# UNITED STATES PATENT AND TRADEMARK OFFICE

APPLICATION NO.	FILING DATE	FIRST NAMED INVENTOR	ATTORNEY DOCKET NO.	CONFIRMATION NO.
10/552,333	10/07/2005	Soo-Sang Yoon	2017-32	1868
<div>52706      7590      04/19/2007</div> <div>IPLA P.A. 3580 WILSHIRE BLVD. 17TH FLOOR LOS ANGELES, CA 90010</div>				
			EXAMINER KIM, SU C	
			ART UNIT 2823	PAPER NUMBER

**Office Action Summary**

## **DETAILED ACTION**

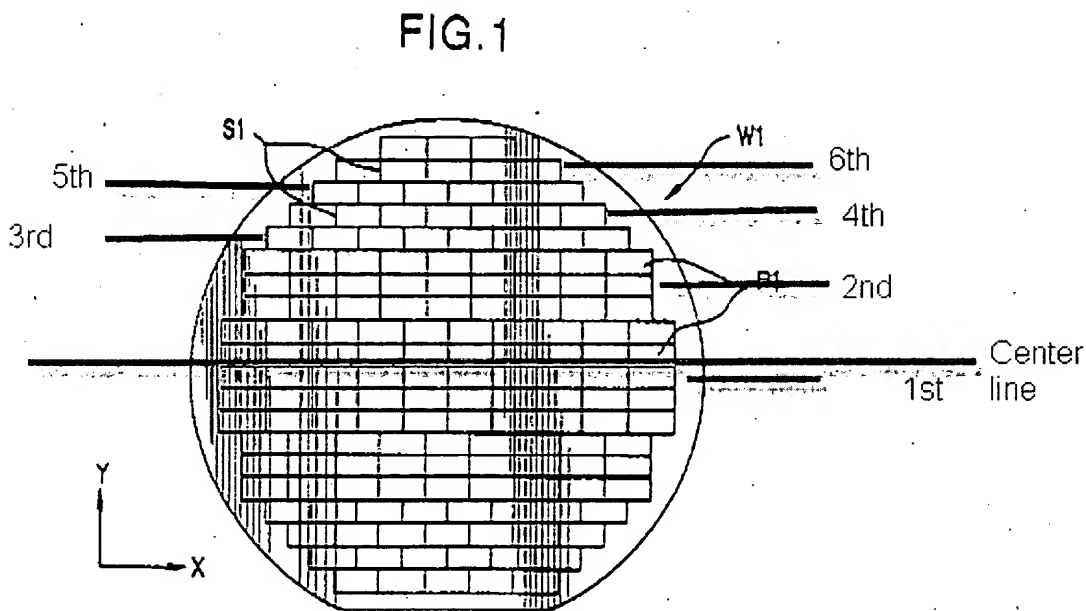
Regarding claim 1, Arai discloses a wafer, wherein a plurality of strips (Fig. 1) having a die arrangement structure in which dies are degned to have an equal width P1

(Fig. 1) are alternately arranged from the center (Fig. 1, note: some of strips are arranged alternately from the center).

Regarding claim 2, as applied to claim 1, Arai discloses first strips (see Fig. 1 below) positioned closest to the center of the wafer adjoin each other to be symmetric with each other, and other strips arranged sequentially on the outside of the first strips are alternately staggered.

first strips which have a die arrangement structure in which their dies are designed to have an equal width (Fig. 1 above, note: the 1<sup>st</sup> strips);

second strips which adjoin the first strips to be symmetric with each other, are arranged in at least one row such that their dies are designed to have an equal width, and are configured in such a manner that their dies are staggered with the respective dies of the first strips (Fig. 1 above, note: the 2<sup>nd</sup> strips);

third strips that adjoin the second strips to be symmetric with each other, are arranged in at least one row such that their dies are designed to have an equal width, and are configured in such a manner that their dies are aligned with those of the first strips but staggered with those of the second strips (Fig. 1 above, note: the 3<sup>rd</sup> strips);

fourth strips that adjoin the third strips to be symmetric with each other, are arranged in at least one row such that their dies are designed to have an equal width, and are configured in such a manner that their dies are aligned with those of the second strips but staggered with those of the first and third strips (Fig. 1 above, note: the 4<sup>th</sup> strips);

fifth strips that adjoin the fourth strips to be symmetric with each other, are arranged in at least one row such that their dies are designed to have an equal width, and are configured in such a manner that their dies are aligned with those of the first and third strips but staggered with those of the second and fourth strips (Fig. 1 above, note: the 5<sup>th</sup> strips);

and are configured in such a manner that their dies are aligned with those of the second and fourth strips but staggered with those of the first, third and fifth strips (Fig. 1 above, note: the 6<sup>th</sup> strips).

Aria fails to teach seventh strips that adjoin the sixth strips to be symmetric with each other, are arranged in at least one row such that their dies are designed to have an equal width, and are configured in such a manner that their dies are aligned with those of the first, third and fifth strips but staggered with those of the second, fourth and sixth strips;
